DEC REQUEST DS 2016-098 STAFF ANALYSIS

ISSUE: DS 2016-098. Petitioner seeks a Declaratory Statement on an interpretation of Chapter 2, Section 206.7 – 206.7.5 and Chapter 4, Section 410 – 410.6 of the Florida Building Code, Accessibility – 5th Edition (2014)

EXHIBIT 'A'

FLOOR PLAN
NO SCALE

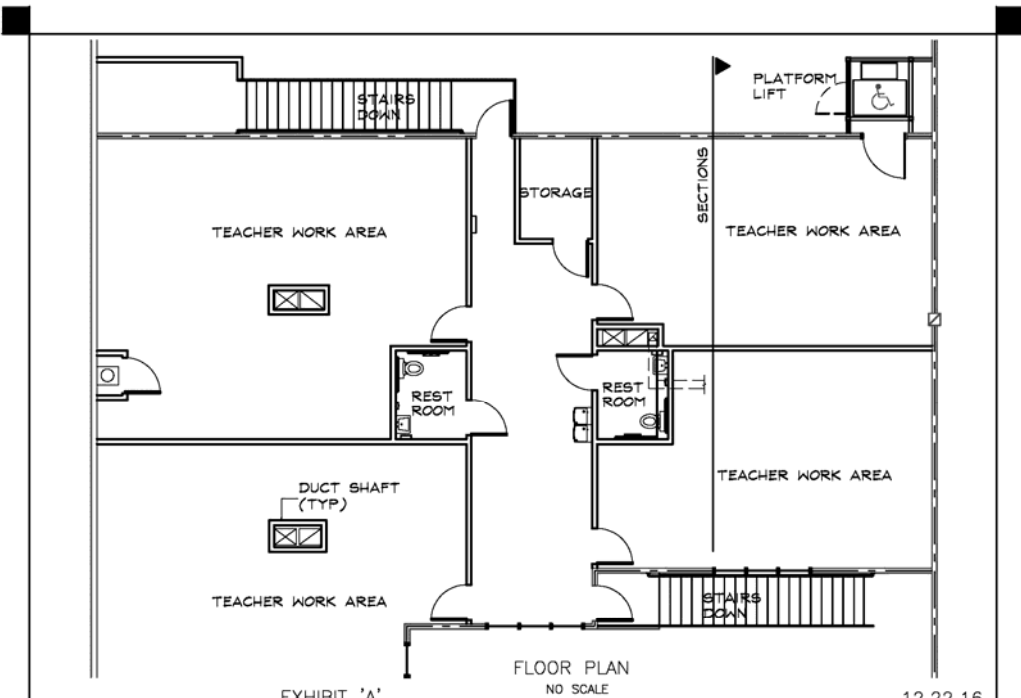
Proposed improvements at the second floor will include two exit stairs, teacher work areas, storage, and restrooms. In order to provide accessibility access to the second floor a platform lift has been proposed. The lift will be located in the northeast corner of the proposed space and will be enclosed by 1-hr rated construction. An attempt was made to configure a shaft for a small, code compliant elevator in this same location; however the dimensional requirements for the cab, interior clearances, shaft walls, and vertical elevator over-run at the second floor precluded the use of an elevator due to interference of overhead roof structure, (36" deep steel trusses with 53" clearance between).

The local permitting authority (Orange County) interprets FBC 2014-Accessibility, section 410 and 206.7 through 206.7.5 to indicate that platform lifts are exclusively used as listed in 206.7.1 through 206.7.5 and are not to be used in any other application. When the structural interference question noted above was brought to their attention as part of the comment response dialog, it was suggested to the petitioner's representative to seek a waiver to provide a platform lift which has no structural interference problems.

To question “is the use of a platform lift acceptable in accordance with FBC 2014-Accessibility sections 410 and 206.7?” The answer is yes. A platform lift that is in compliance with Sections 410 and 206.7 and listed/certified for the intended use is acceptable for the project in question.

To question “should a waiver be required for a design that apparently meets code requirements?” The answer is no. A waiver application is not necessary for the project in question.
